#### NOTICE OF ADDENDUM ADDENDUM NO. 4

# CONTRACT NO. 9226, PROJECT NO. 12393 Phase 2 CCB City Office Remodels, First and Fifth Floors

## CONTRACT NO. 9226, PROJECT NO. 12393 Phase 2 CCB City Office Remodels, First and Fifth Floors

E000N SYMBOLS. ABBREVIATIONS & DETAILS - ELECTRICAL

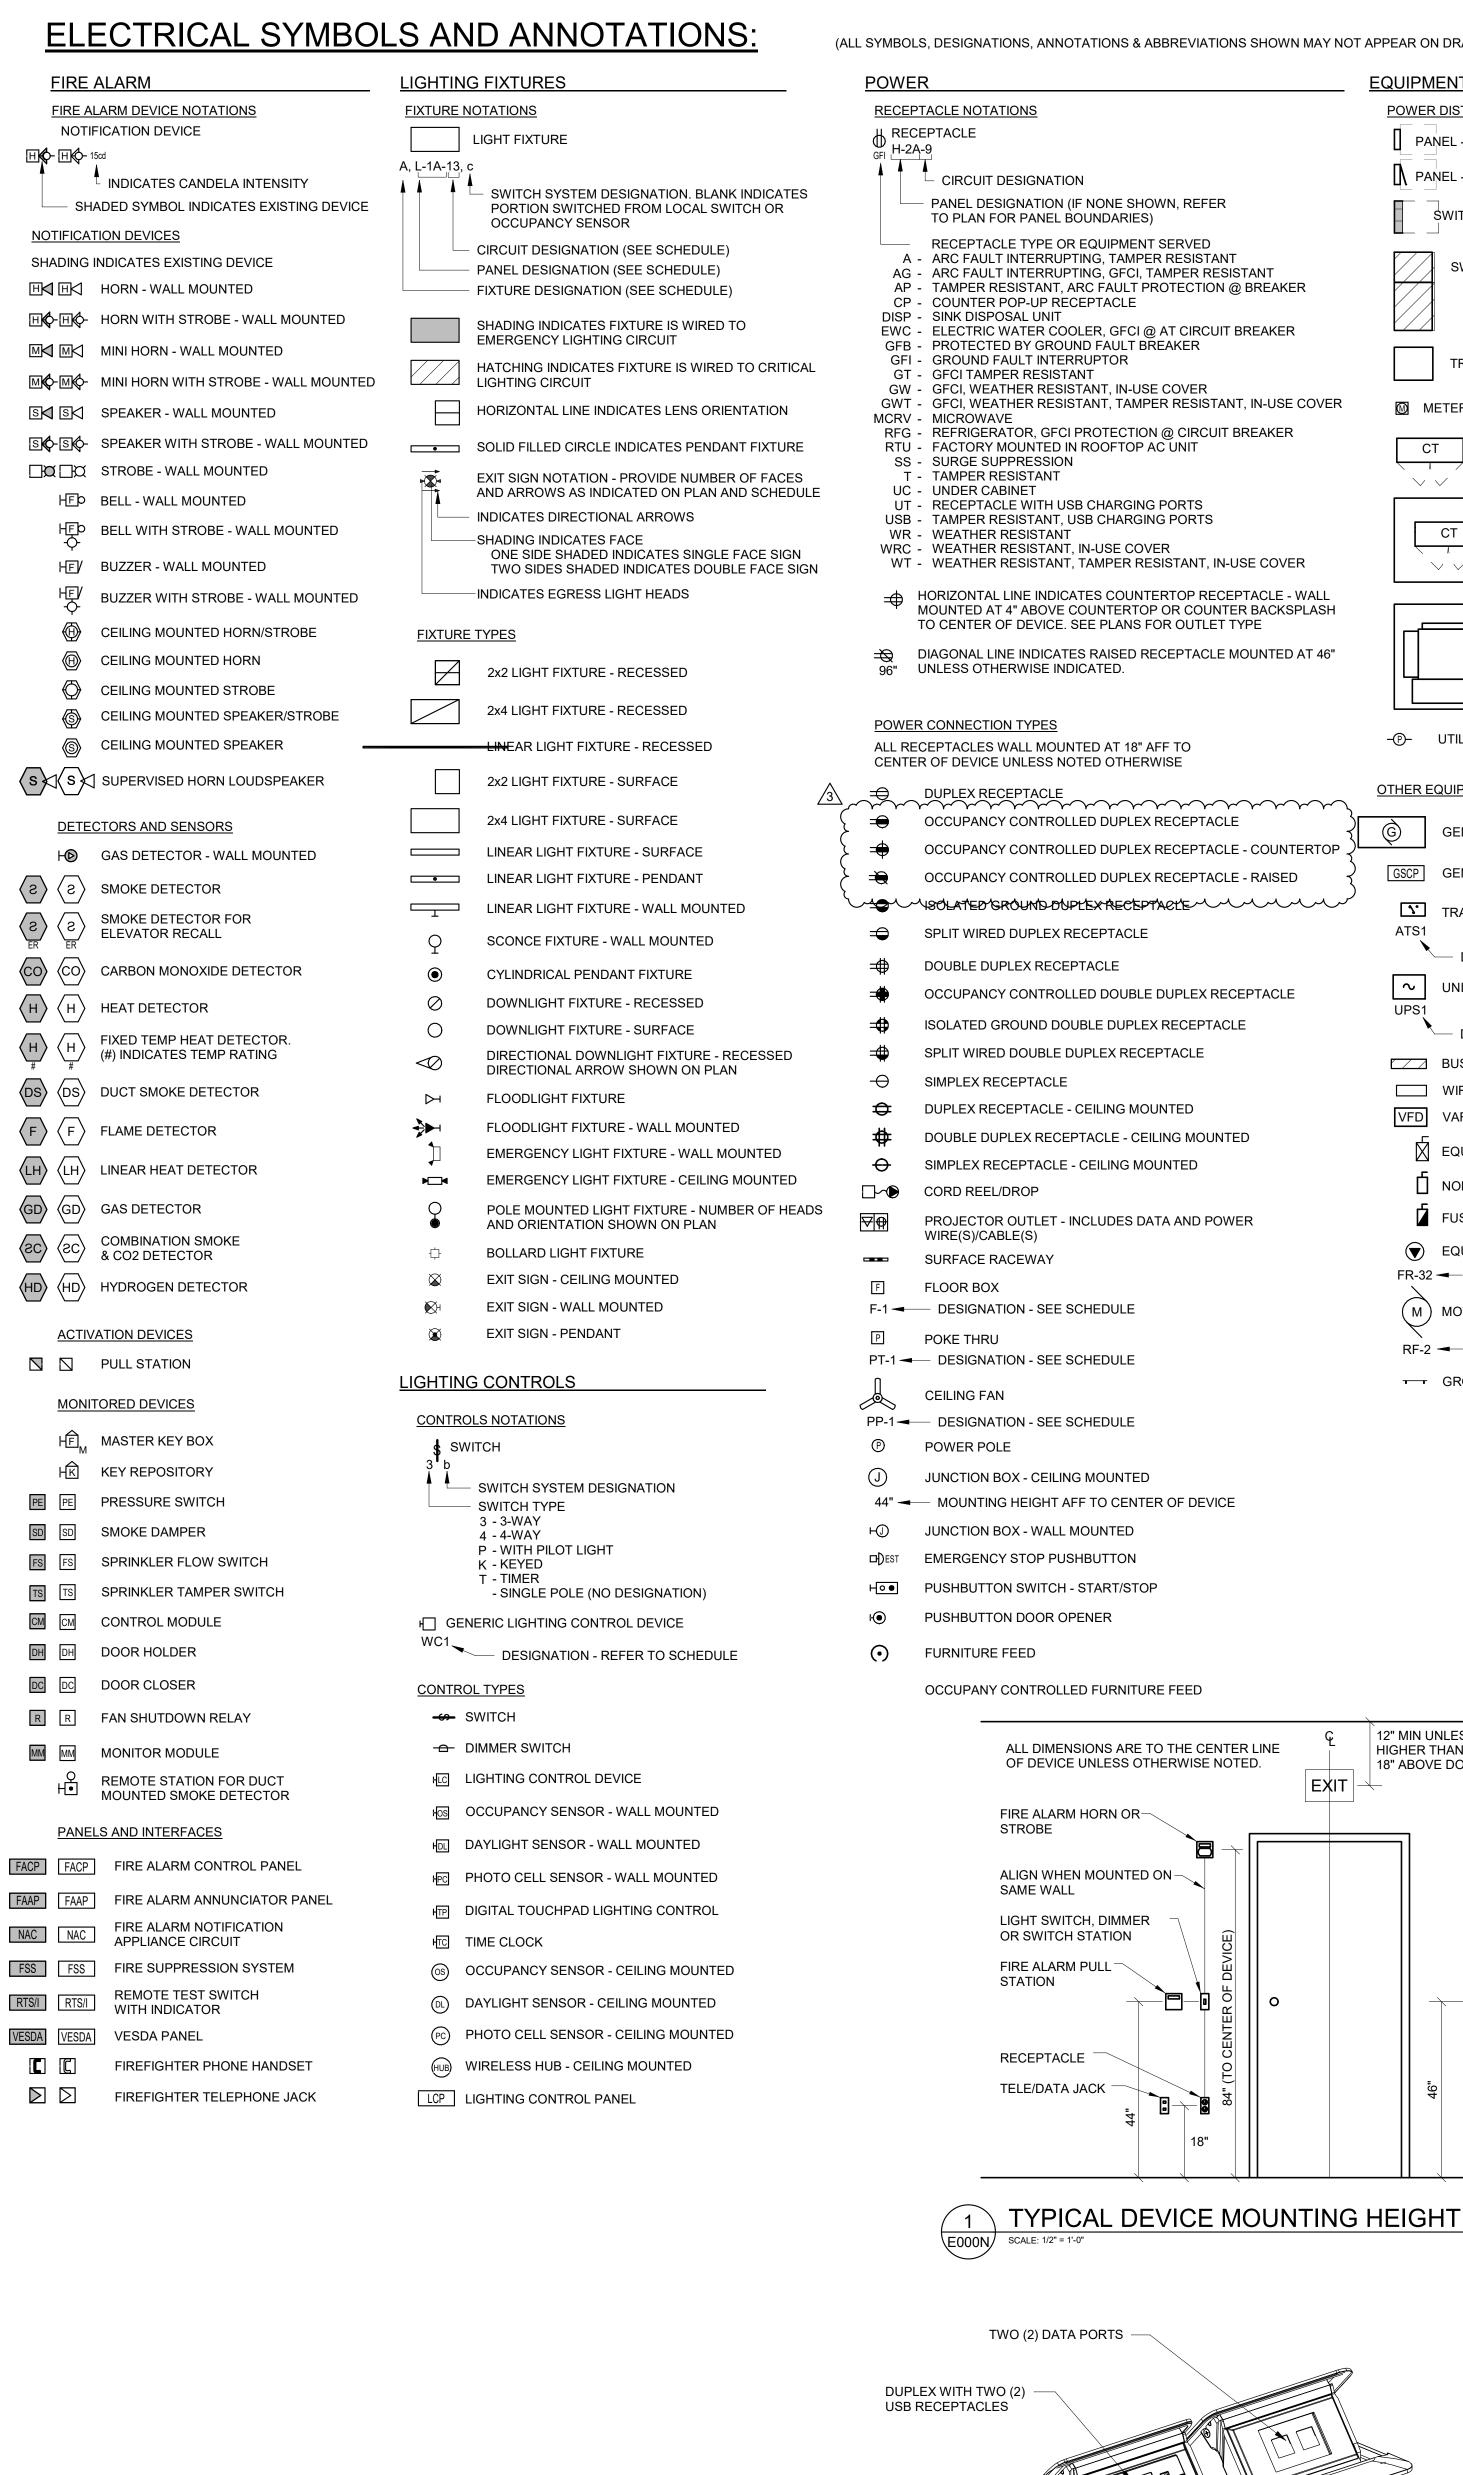
- A. The following sheets have been modified, and are provided with "Exhibit H Revised Plan Sheets.pdf" on Bid Express. Red clouds and notes identify the changes on each sheet.
  - 1. Sheet E000N Electrical Symbols and Annotations Clarification that the "Occupancy Controlled Receptacle" symbol should be an "Occupancy Controlled Duplex Receptacle".
  - 2. Sheet E000N Electrical Symbols and Annotations Clarification that the "Occupancy Controlled Duplex Receptacle" and "Occupancy Controlled Double Duplex Receptacle" symbols are also shown on the plans with a horizontal line indicating a countertop receptacle and a diagonal line indicating raised receptacle at 46" unless otherwise indicated.
  - 3. Sheet E801N Lighting & Receptacle Controls Schedule Revise schedule to include the additional symbols associated with the occupancy controlled receptacles.
